# TERRY CORPORATION

## REPORT OF POTENTIAL SAFETY HAZARD, 10CFR21 (PART 21 OF TITLE 10 OF THE CODE OF FEDERAL REGULATION)

PART NAME Rev. Chamber Lock Plate Screws QUAN. \_\_\_\_\_

TITLE  
REVERSING CHAMBER FASTENING  
CCS

DRAWING NO. HW-12877

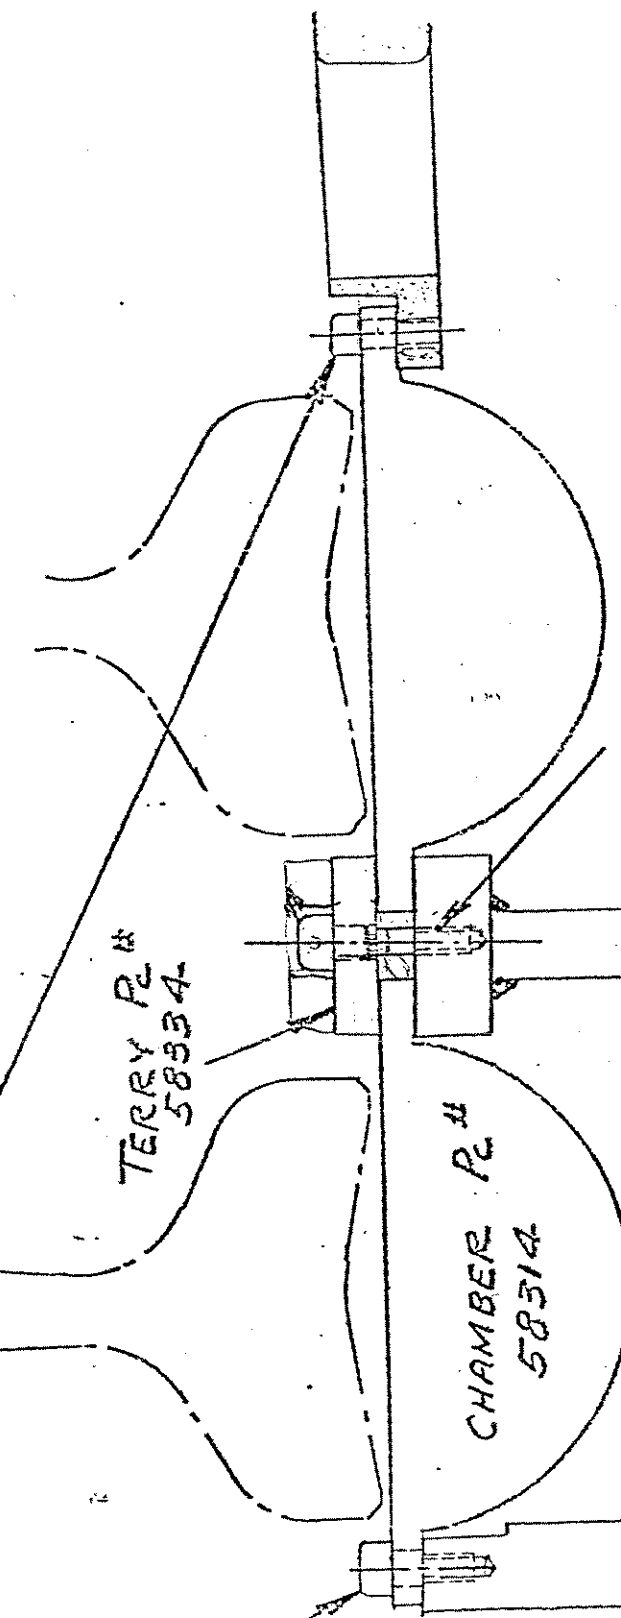
DESCRIPTION OF POTENTIAL SAFETY HAZARD OR NON-COMPLIANCE: \_\_\_\_\_  
Recent breakage of lock plate screws at Peach Bottom coupled with attached telex from SNM indicates a design problem which could cause reversing chambers to break free and affect operation of HPCI units.

ENGINEERING EVALUATION & RECOMMENDATION: Does not constitute a reportable safety hazard.  
A design improvement is required to eliminate breakage of screws #DT5U066 shown on attached drawing HW-12877.  
Engineering to devise a retrofit kit for field modifications of all affected units. Upon availability of kits, customers are to be notified of the design improvement and correction procedure.
